**ADDENDUM No. 2
for
INVITATION FOR BID (IFB)**

WESTERN DRIVE SEWER IMPRVEMENT

**TOWN OF LONGMEADOW
MASSACHUSETTS**

October 9, 2019

SHEET 3 of 4

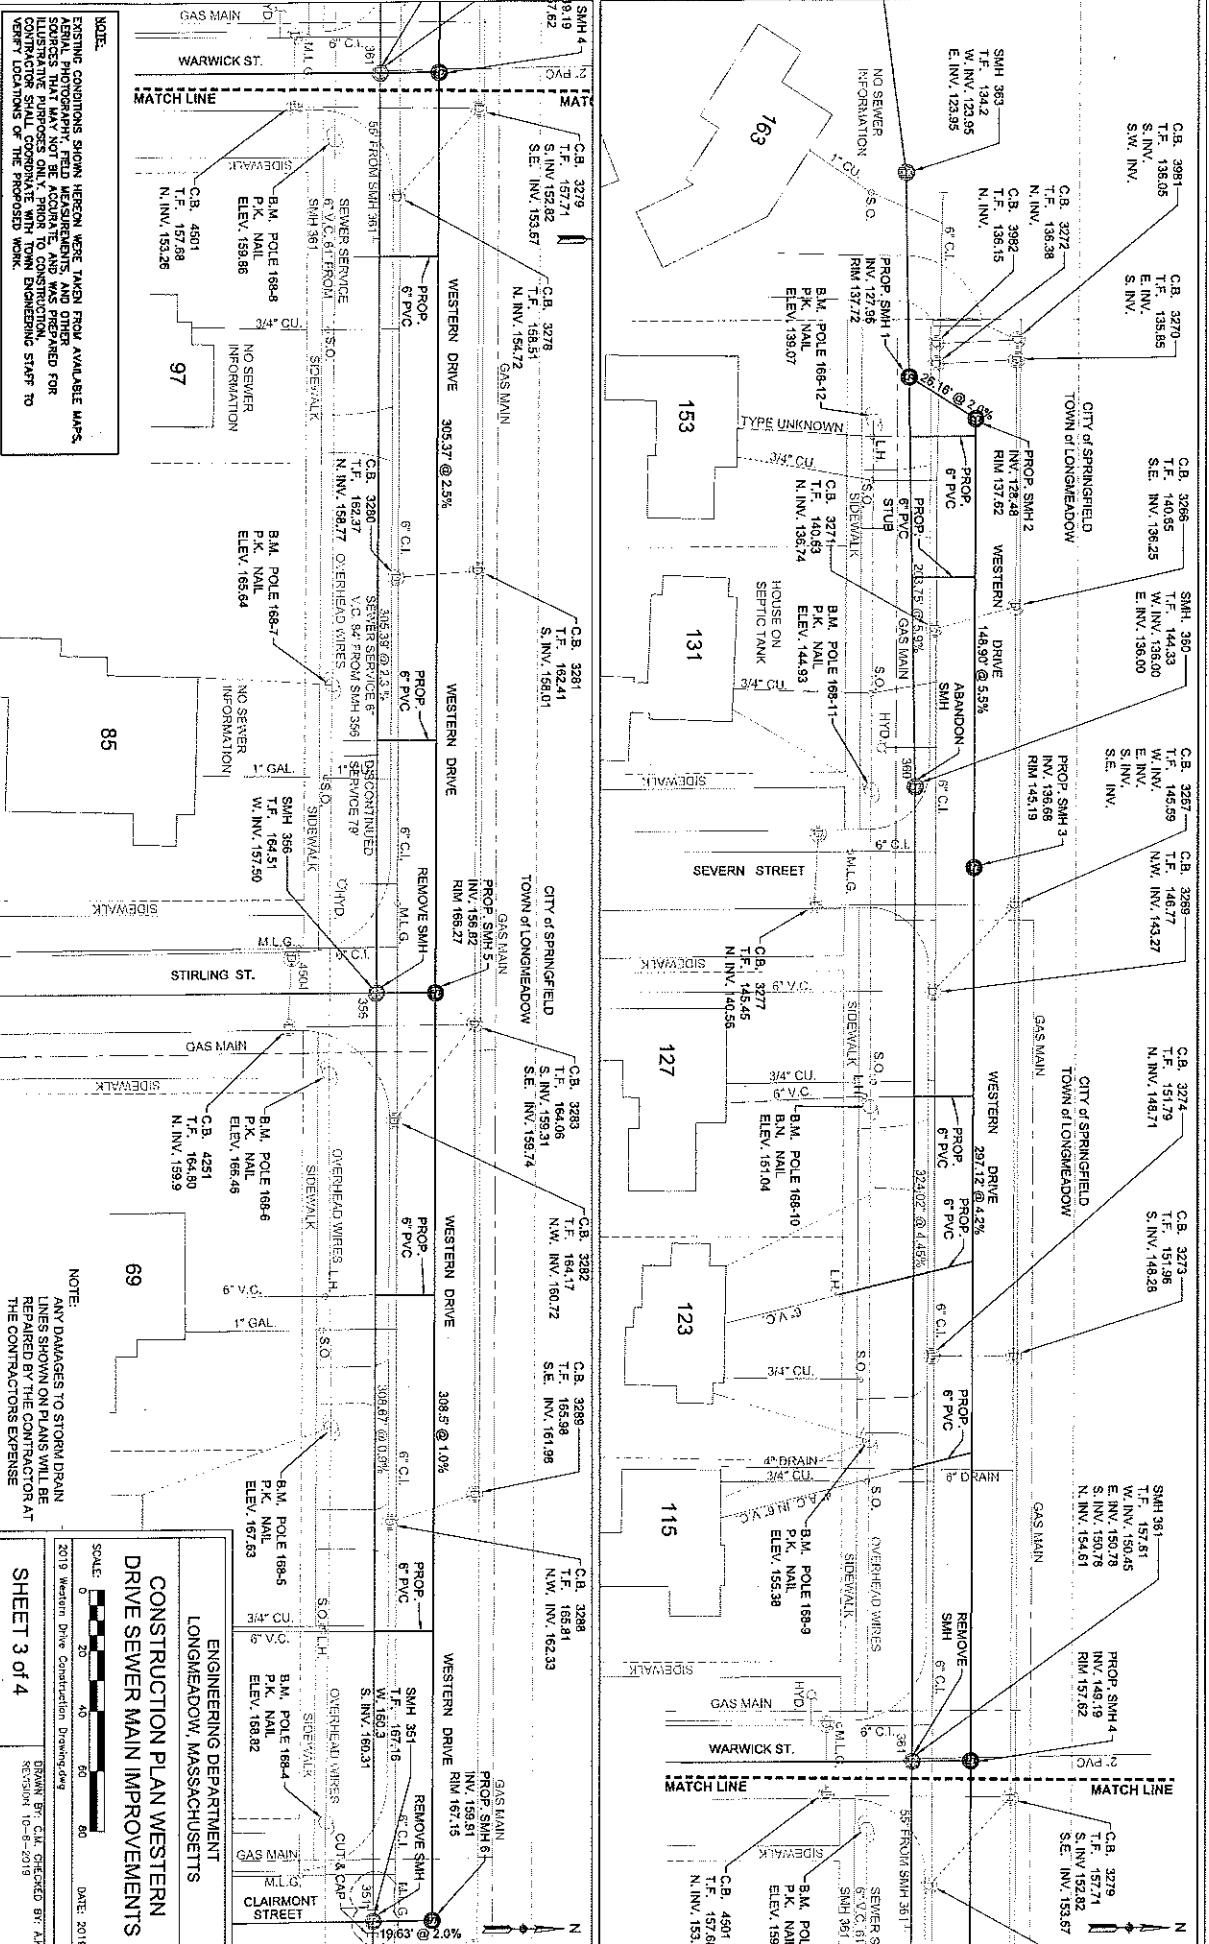
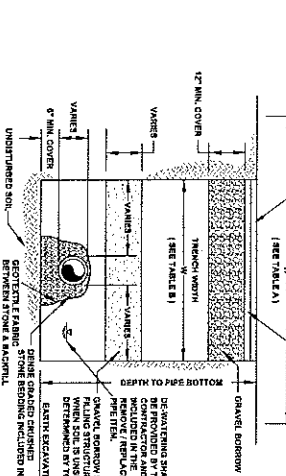
QUESTION: On the plans it shows existing SMH 351 having an inlet from the South and West. From what I can tell the plans do not address the pipe from the West invert being tied into the new section of sewer main. Unless I am looking at it wrong.

RESPONSE: See Attached revision of plans for question on SMH 351.

SEWER TRENCH SECTION IN ROAD WAY
NOT TO SCALE

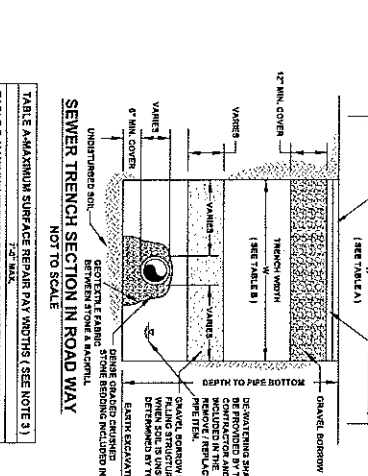
QUESTION: Can clarification be provided on item 703.1?

The detail talks about a 2" mill & machine-paved overlay.

However, I don't see it again mentioned anywhere.

Will a 2" Mill and machine-paved overlay of the trench indeed be required?

RESPONSE: There is no mill required, two inches of base and two inches of top Hot Mix Asphalt. See Attached Revision of details.

FINISHMENT TRENCH FACING 2" OR MORE
MIX ASPHALT TOP SHALL BE PAVED
WITH MECHANICAL PAVING.
SURFACE REPAIR WIDTH
(SEE TABLE A)
